MAINTENANCE TECHNICAL SUPPORT CENTER
HEADQUARTERS MAINTENANCE OPERATIONS
UNITED STATES POSTAL SERVICE

Software Modification Order

SUBJECT: Mailing Evaluation, Readability, and Lookup
INstrument (MERLIN) Software Version
07.10.00

NO: SMO-024-12
FILE CODE: A9

Figure 1-5. Sample MERLIN Dialog Box 1 for Next MPID

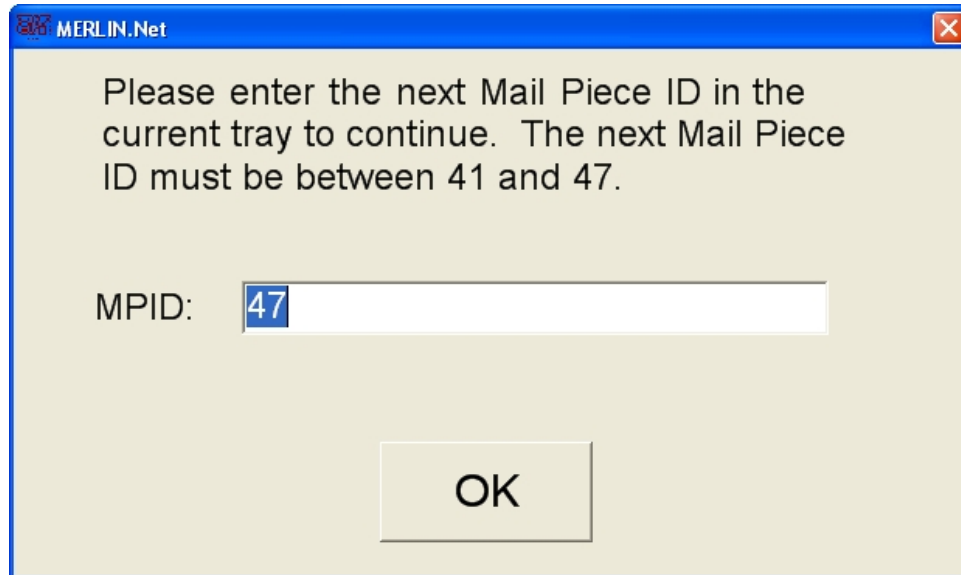
This issue is caused by an invalid MPID entered by the user after a transport stoppage such as a jam. After user clears the jam, MERLIN will prompt the user for the next MPID to continue. If user enters an invalid MPID such as an MPID from a previous tray, then MERLIN will start with a negative value or count backward in the Run System screen's "Pieces in Tray" field.

The MERLIN software has been modified to prevent user from entering an invalid MPID during an evaluation run after a transport stoppage. The valid MPID range that MERLIN will accept will be displayed in dialog box as shown in Figure 1-5. Note MERLIN will also provide / suggest the MPID it expects.

Figure 1-6. Sample MERLIN Dialog Box 2 for Next MPID

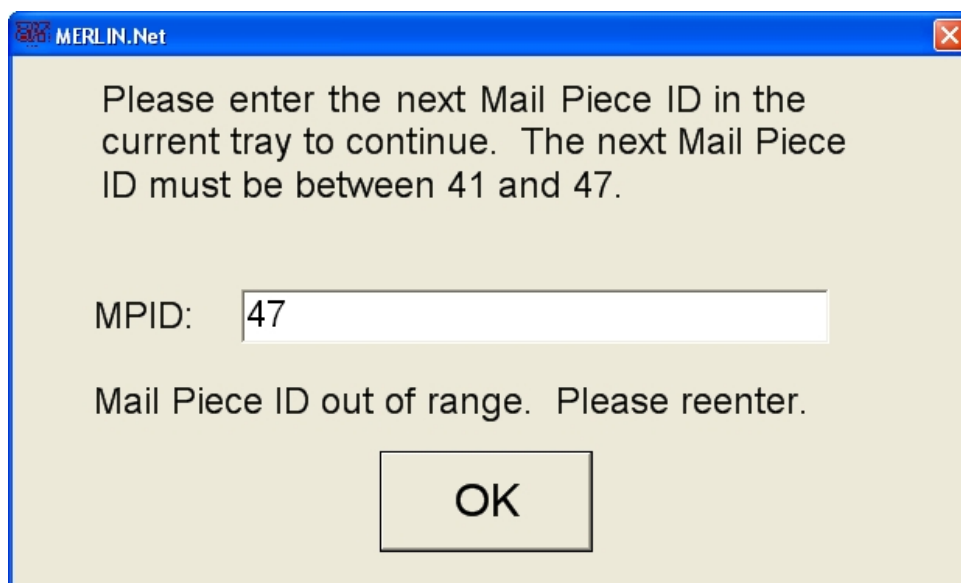
User must enter a MPID within the acceptable range (within the current tray). If user enters a MPID that is not within the acceptable range, MERLIN will not accept the invalid MPID and display another dialog box as shown in Figure 1-6 prompting the use to reenter the MPID.

Figure 1-9. Report MERLIN Problem Menu Option

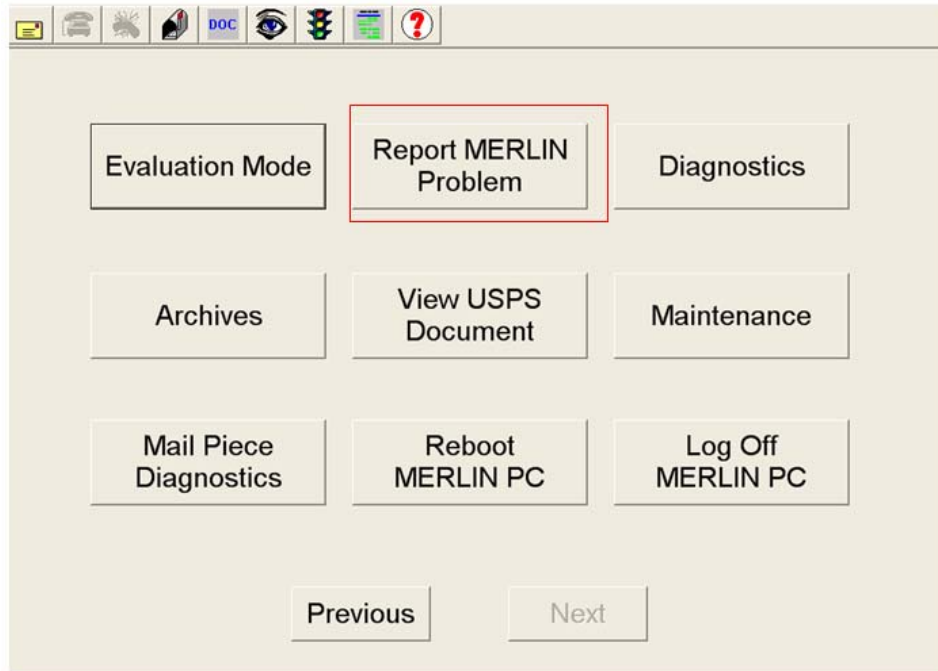
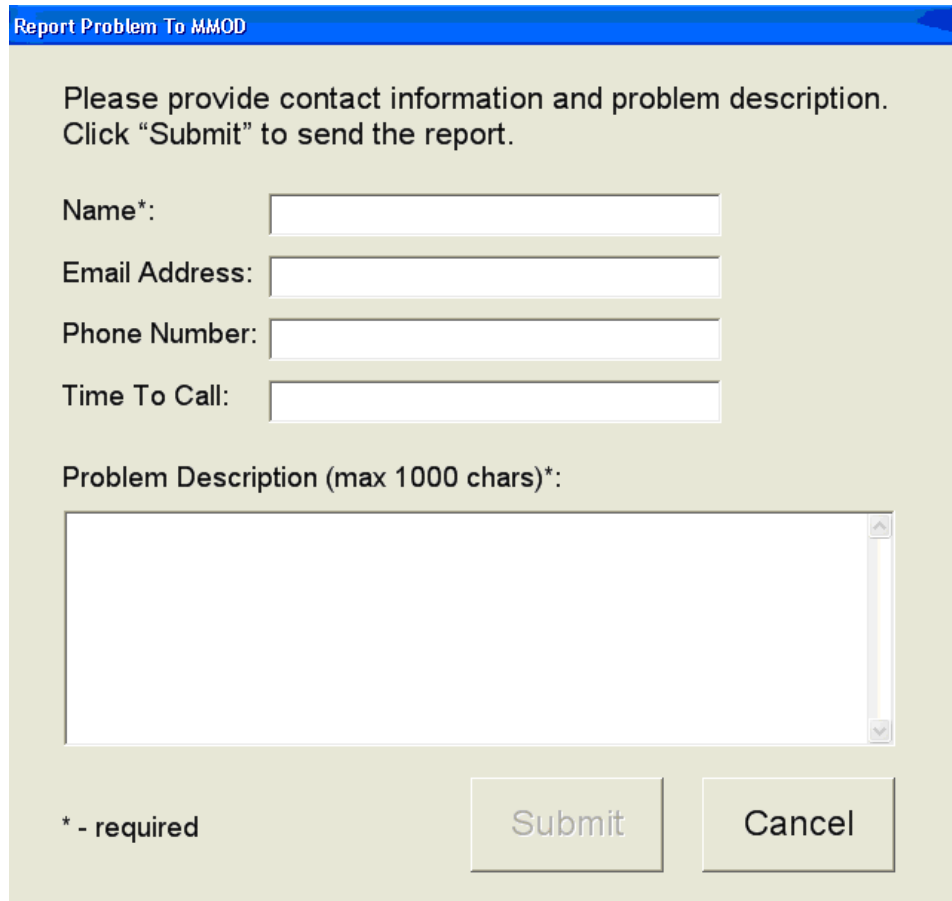
A new option, “Report MERLIN Problem”, has been added to the MERLIN main menu as shown in Figure 1-9. The Report MERLIN Problem menu option will be available to all MERLIN users (Administrator, Maintenance and Operator).

Figure 1-15. Sample Address Block with Mailer Applied Barcode

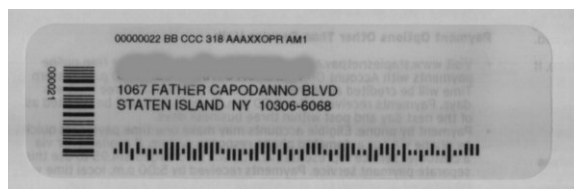
The MERLIN software has been modified to improve block formation to better recognize gaps between regions of interest. This change will allow MERLIN to be able to recognize and decode valid barcode printed in a windowed envelope even if there is a mailer applied barcode such as a Code 128 barcode printed to the left of the IMB as shown in Figure 1-15. Sample Address Block with Mailer Applied Barcode.

Figure 1-16. Updated MERLIN Warning Message 11043

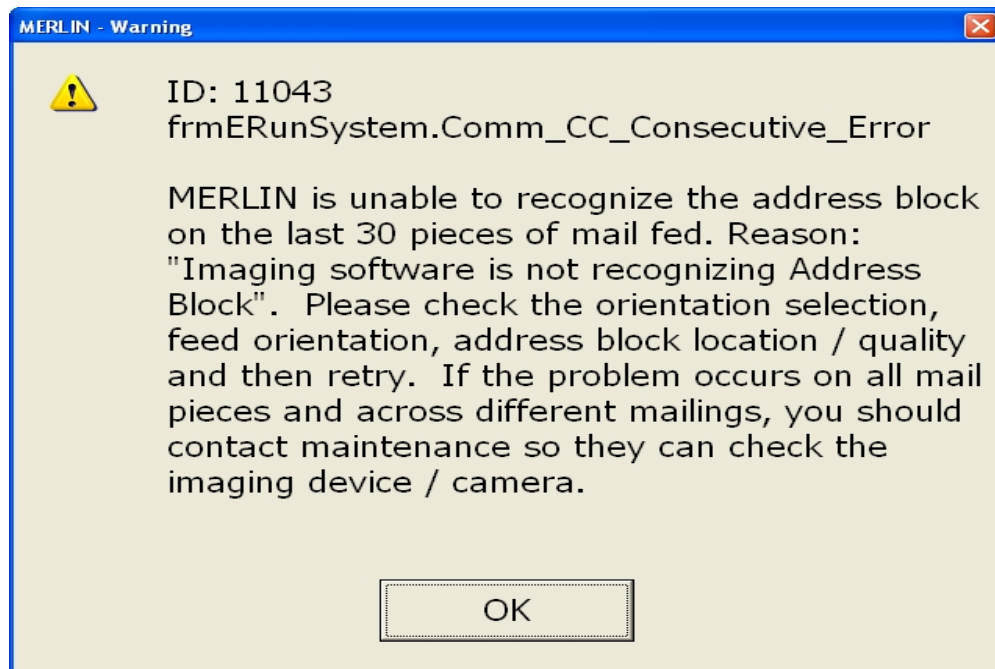
The MERLIN software has been modified to display the 11043 error message only when the last 30 consecutive mail piece's address block had not been captured / identified while IPA is still communicating with the control software. The 11043 message was also modified as shown in Figure 1-16. Updated MERLIN Warning Message 11043 to display the reason for getting no address data. This message ID will no longer display in case IPA has crashed and is not sending any data.

Figure 1-17. MERLIN Warning Message 11118

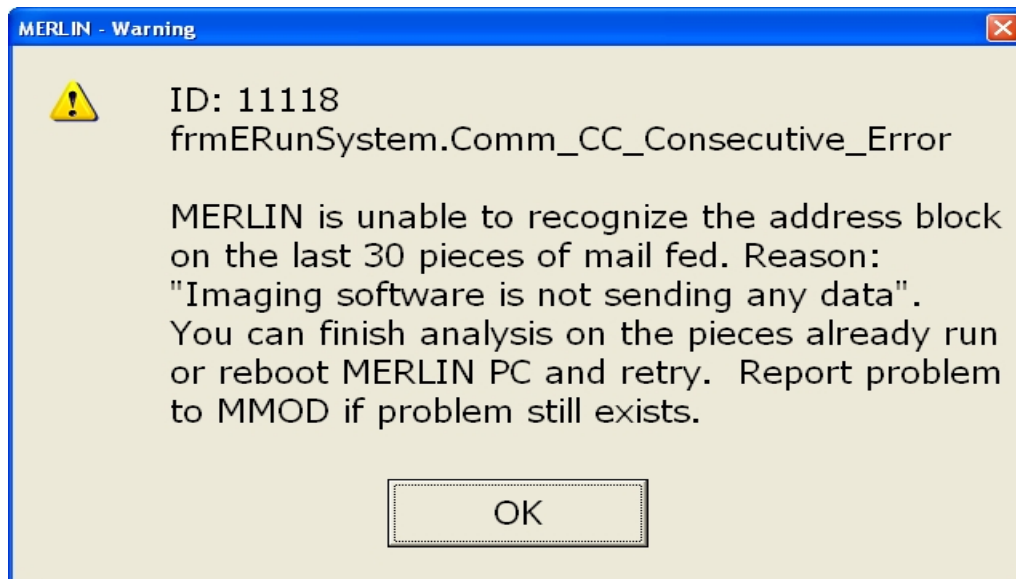
In the event that during a MERLIN run no data is received from the IPA for 30 consecutive pieces due to an IPA crash, a new message with ID 11118 will be displayed as shown in Figure 1-17. The message would inform the user that IPA is not sending any data and instruct the user to either analyze the job with the pieces already run or reboot and retry. MERLIN software has been modified to not allow operator to continue adding more mail pieces to this job. After the message is displayed the user can either abort the job or finish analyzing the job with the pieces that have already been run. It is recommended that MERLIN be rebooted after this message appears to allow IPA software to restart. This message would also trigger the new MERLIN functionality that allows the reporting of MERLIN problem to MMOD.
